# Bulletin

## Opel Corsa D

**Engine: A13DTC, Z13DTJ, - A13DTC, Z13DTJ**

### **Chirping noise coming from the engine compartment.**

Illustration 1

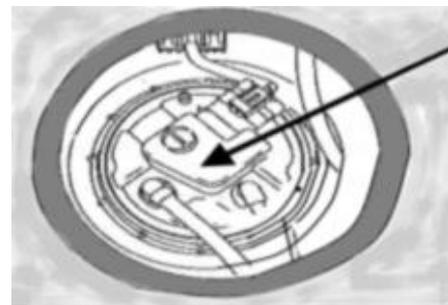
With these vehicles, the fuel pump to be installed should have 13252214 as its production number (Spare part no.: 93190773) (For position of the part number see arrow / Illustration 1). If the fuel pump having the production number 13252213 has been installed, this is to be replaced.

- Remove rear seating.
- Lift up felt covering / service cover (see picture 1).
- Check the part number of the fuel pump and, if necessary, replace the fuel pump and the sealing ring.
- Check the part number of the fuel line and replace if necessary.
